Subject: CTO-0128: Response to Regulatory Comments on the Revised Draft Engineering Evaluation/Cost Analysis for IRP Site 1, Inactive Landfill, Former Naval Training Center, Proposed Grading Plan, Port of San Diego, Northern Portion of Landfill and Conceptual Models for Consolidation Alternatives, IRP Site 1

**RESPONSE TO REGULATORY COMMENTS ON THE REVISED DRAFT ENGINEERING EVALUATION/COST ANALYSIS  
(EE/CA) FOR INSTALLATION RESTORATION PROGRAM (IRP) SITE 1, INACTIVE LANDFILL,  
FORMER NAVAL TRAINING CENTER, SAN DIEGO  
CTO-0128**

**CTO-128 Former Naval Training Center, San Diego**  
**IR Site 1, Inactive Landfill**  
Removal Action Alternative  
Assumptions for Conceptual Models 1, 2, and 3  
October 14, 1999

**CONCEPTUAL MODEL 1 (Figure 1)**

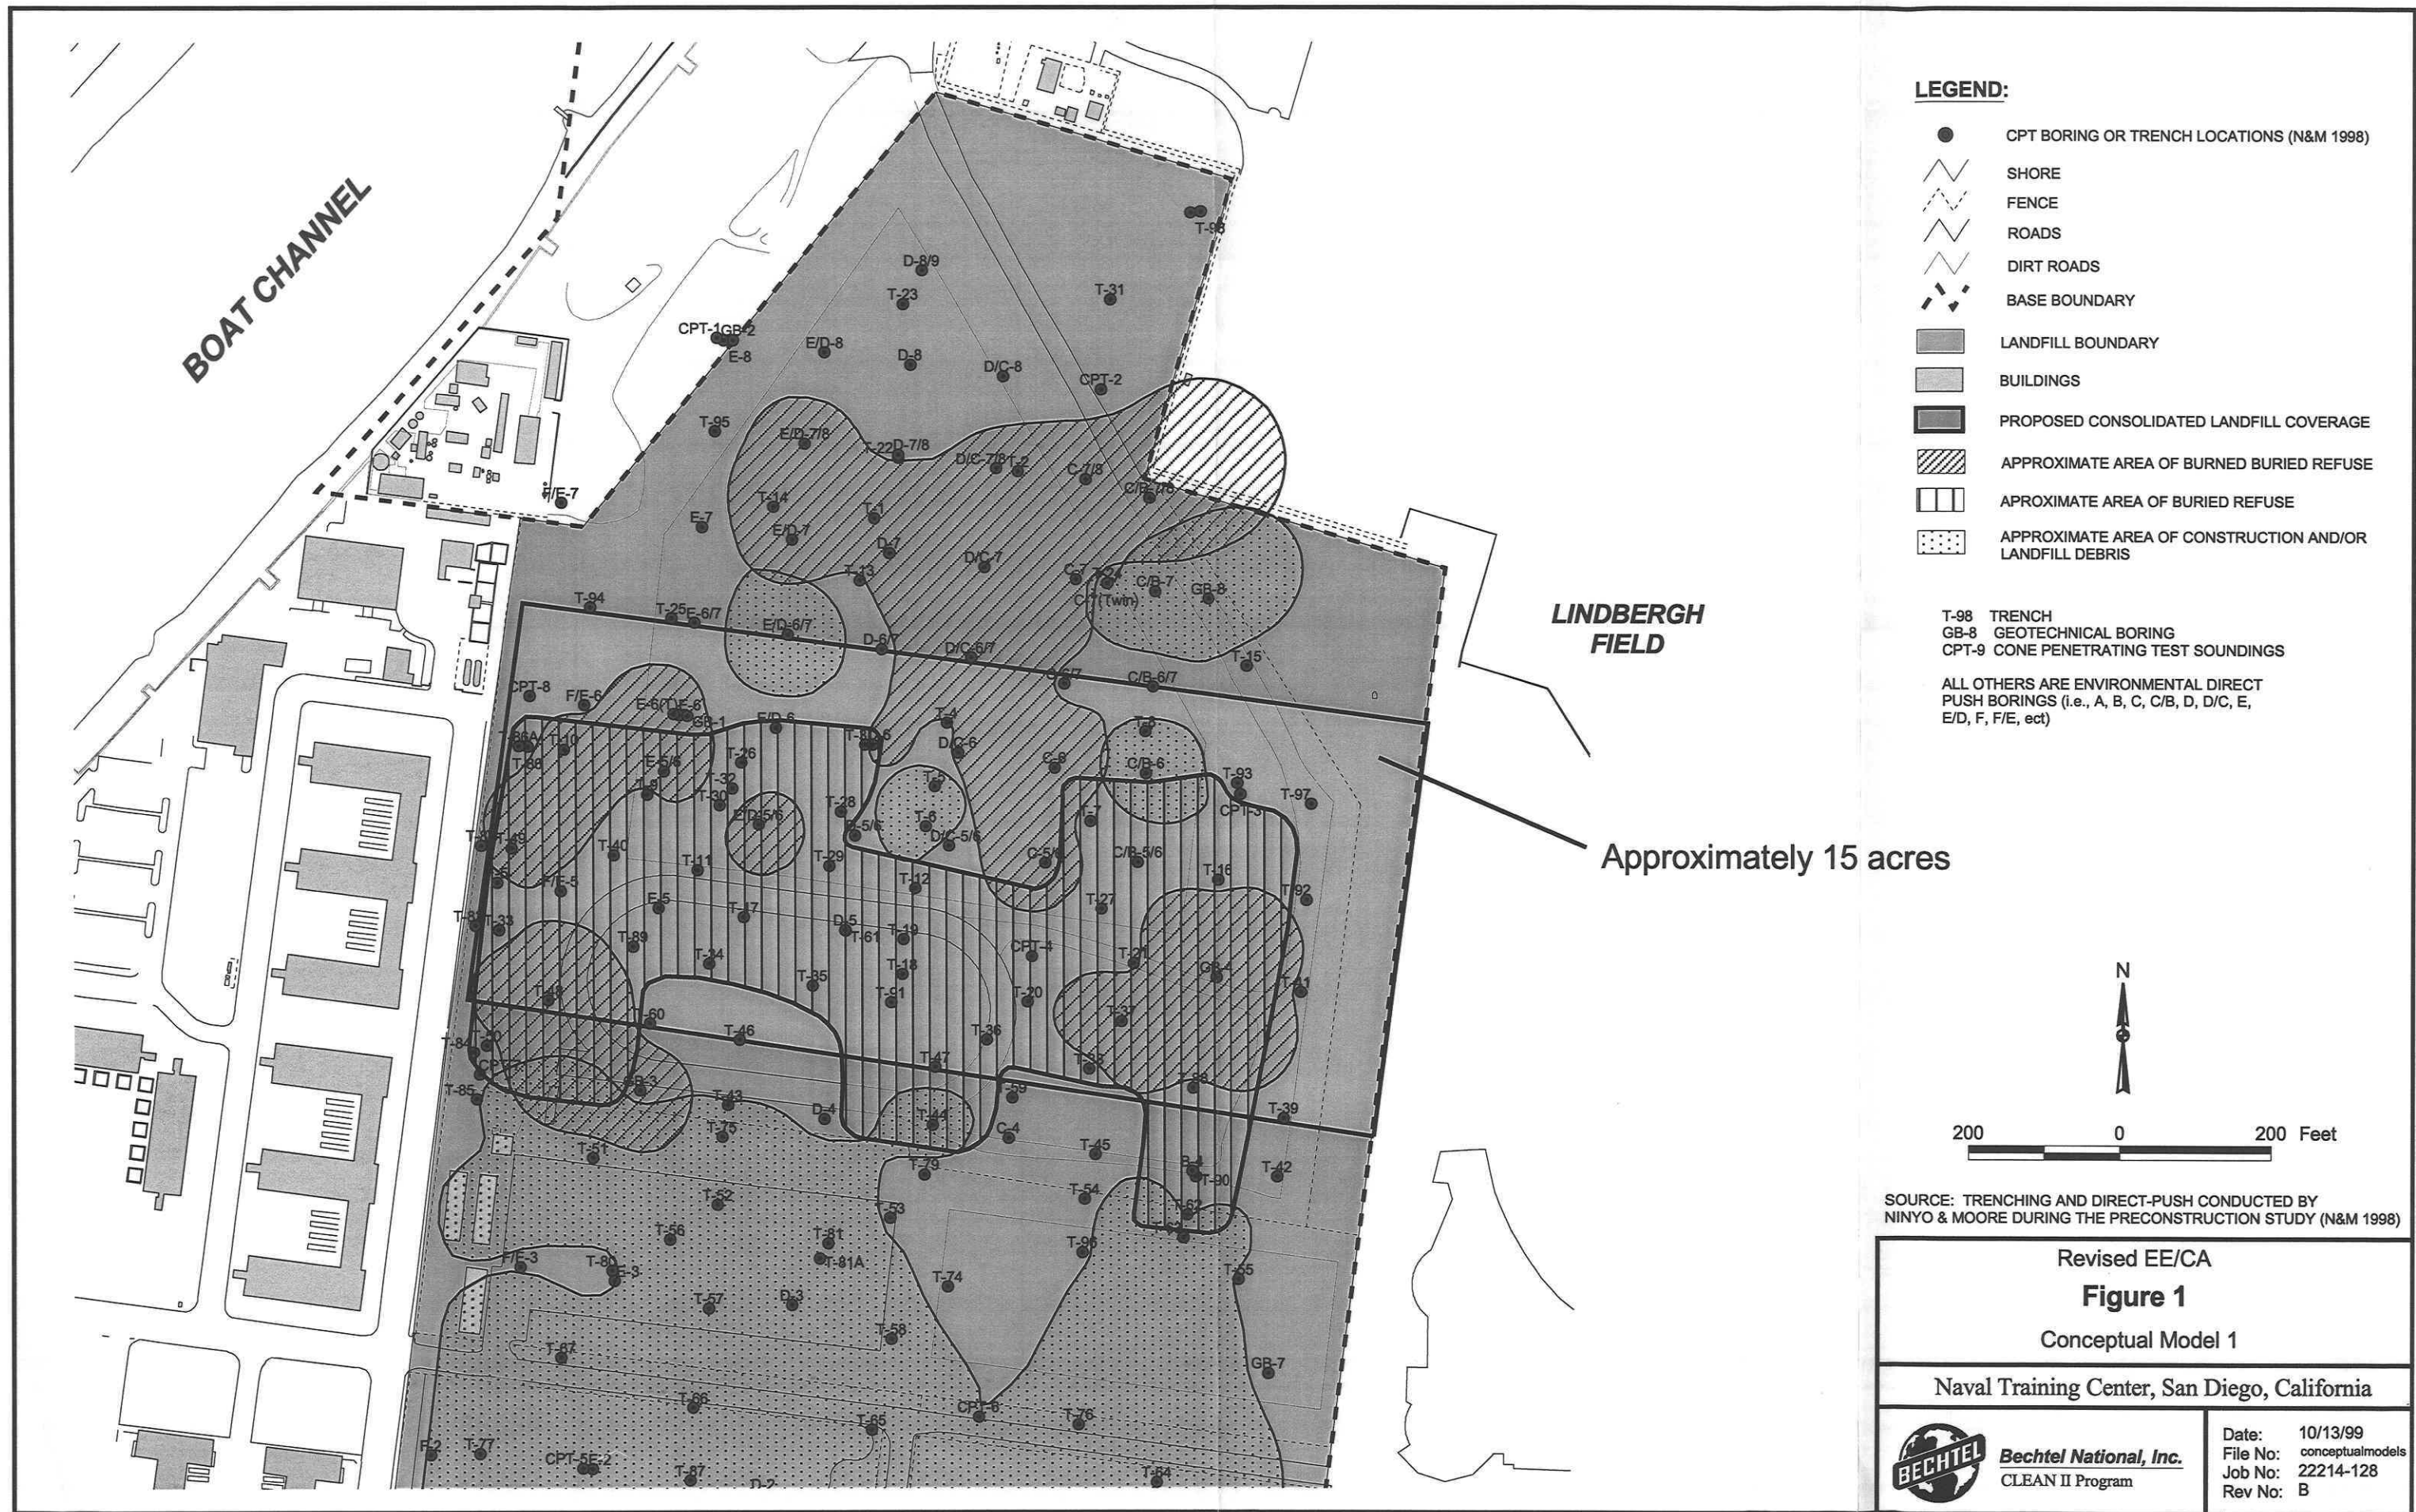
- Size: 1200 feet by 600 feet (approximately 15 acres)
- Calculated minimum slope: 1.5 % (east to west) by 3% (centerline of the proposed landfill cover to existing grade in the north and south directions)
- Minimum height requirement: 9 feet (includes a minimum 2 foot final cover)
- Approximately 63,000\* cubic yards of waste to be consolidated
- This model provides adequate room to accommodate all waste under the cover.

**CONCEPTUAL MODEL 2 (Figure 2)**

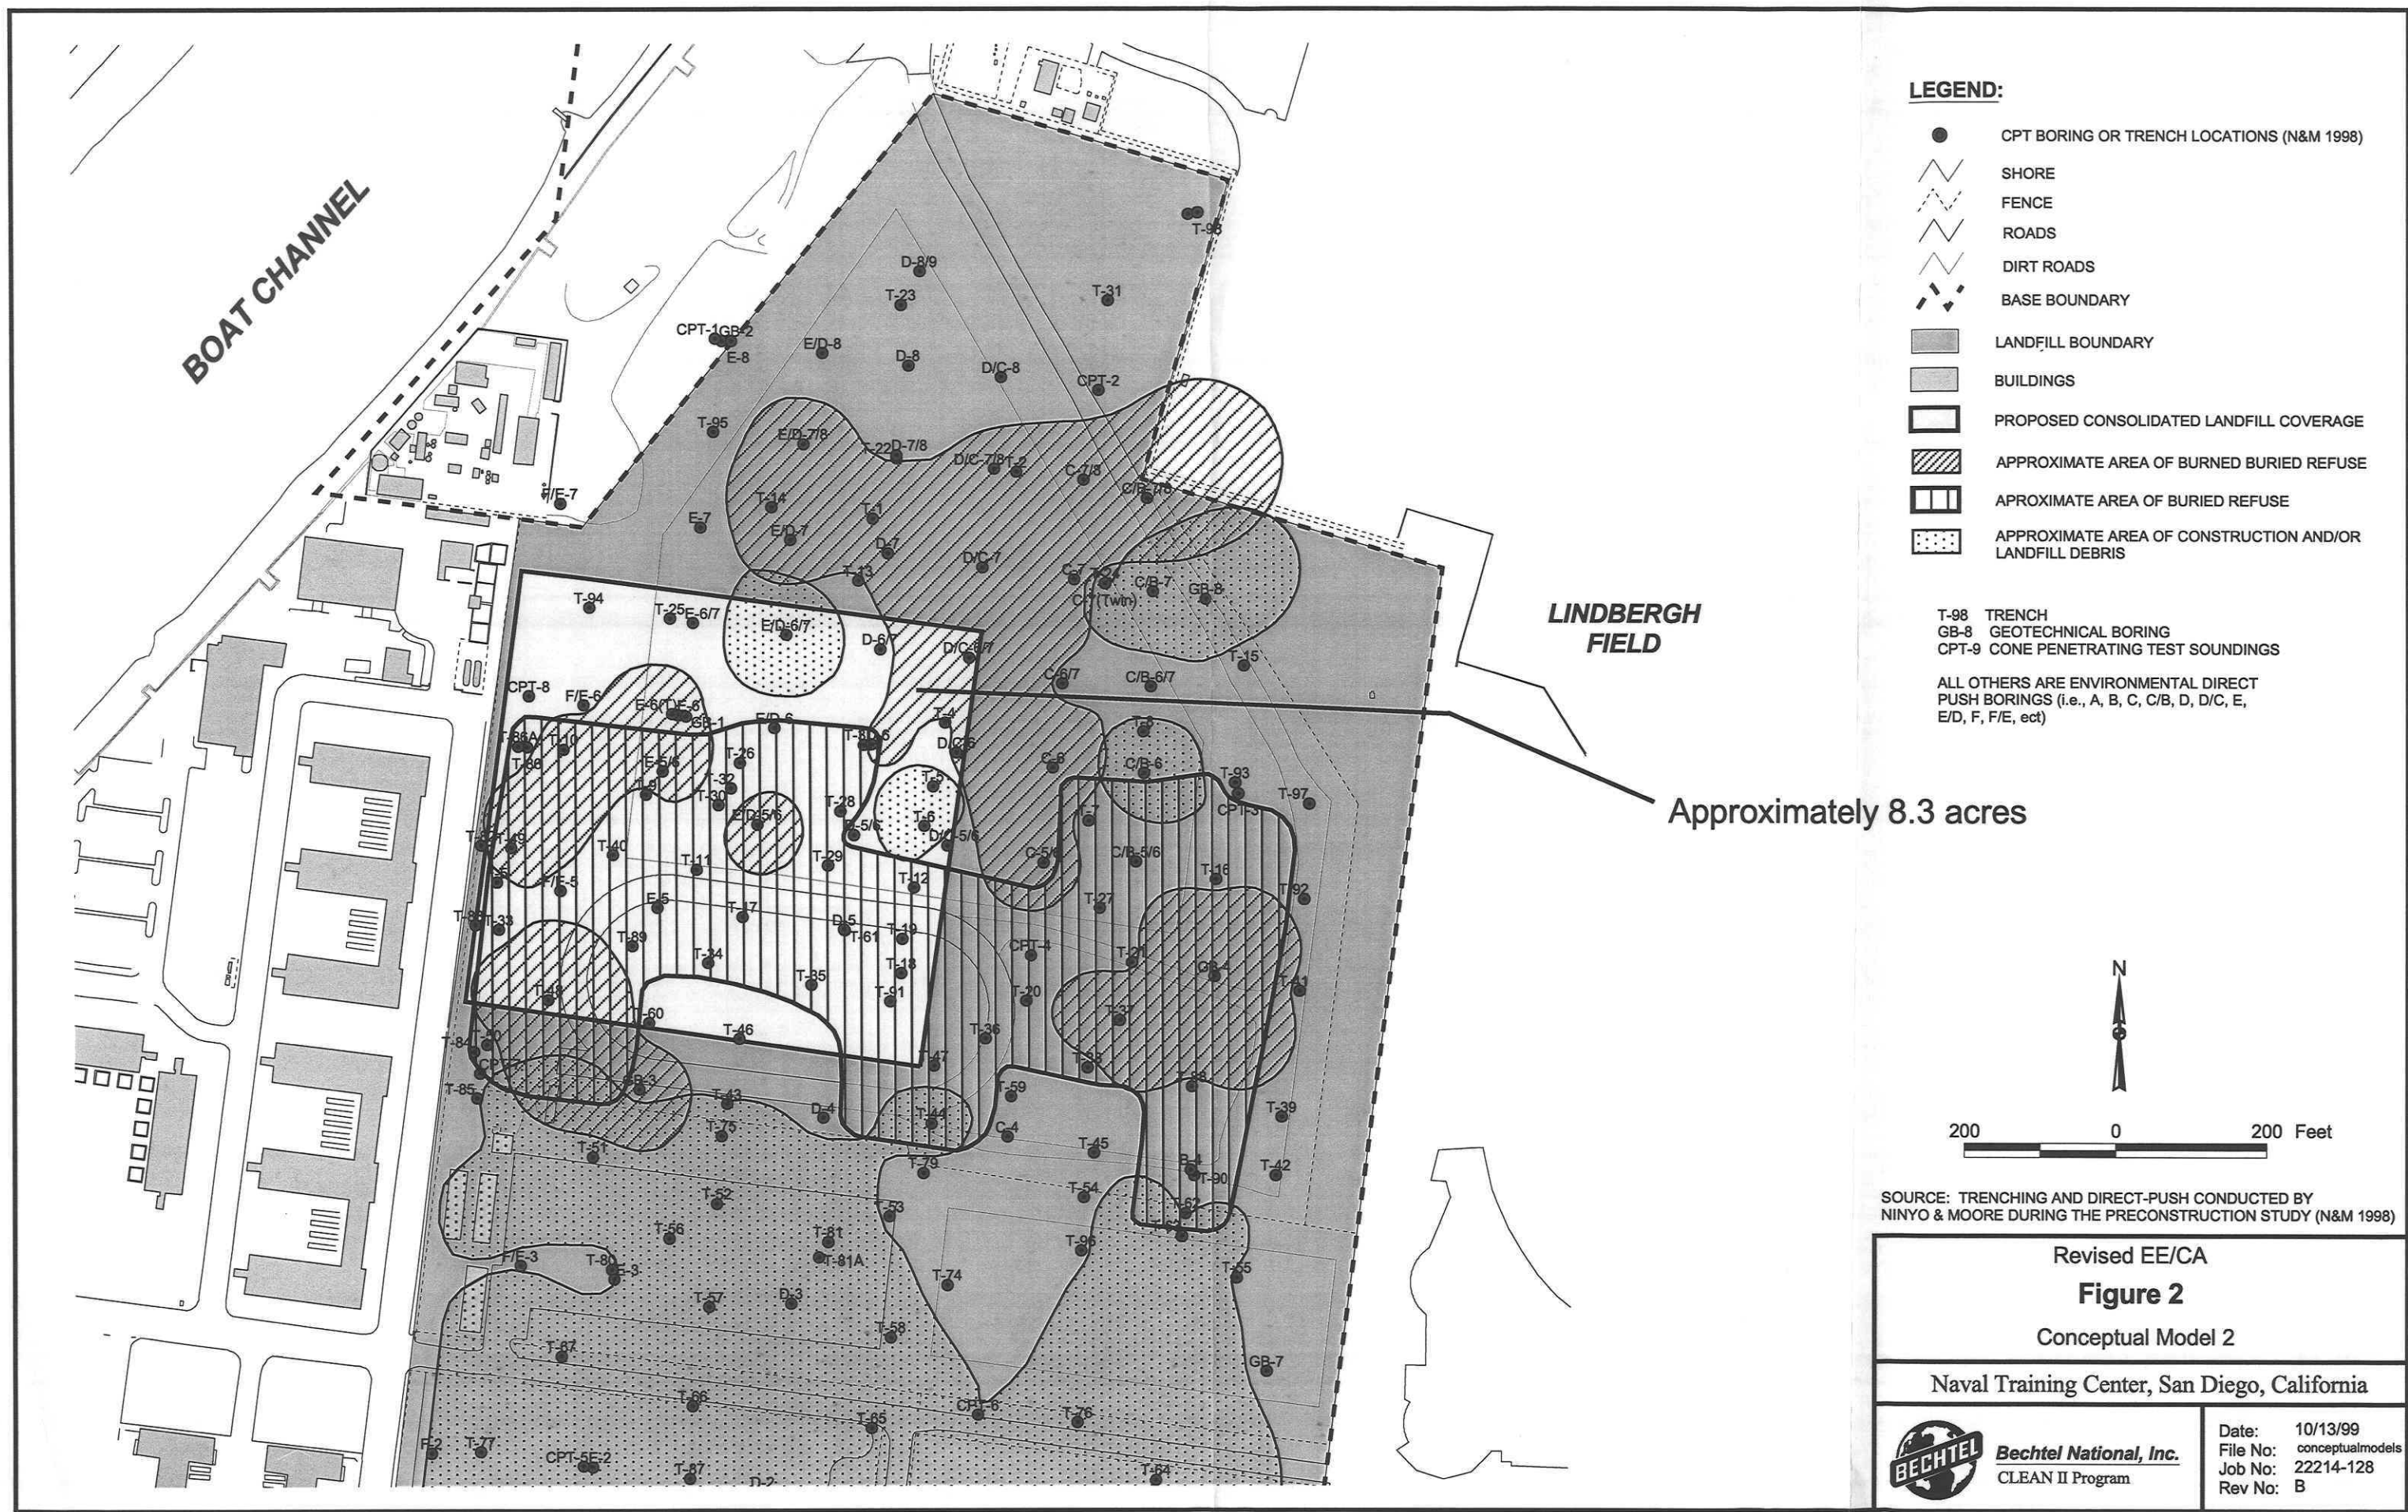
- Size: 600 feet by 600 feet (approximately 8.3 acres)
- Calculated minimum slope: 4% (both ways)
- Minimum height requirement: 11.8 feet (includes a minimum 2 foot final cover)
- Approximately 64,000\* cubic yards of waste to be consolidated
- This model does not provide adequate room for all waste. In order to accommodate the waste, the height and sidewalls would have to be extended in a vertical manner, which is not a favorable alternative.
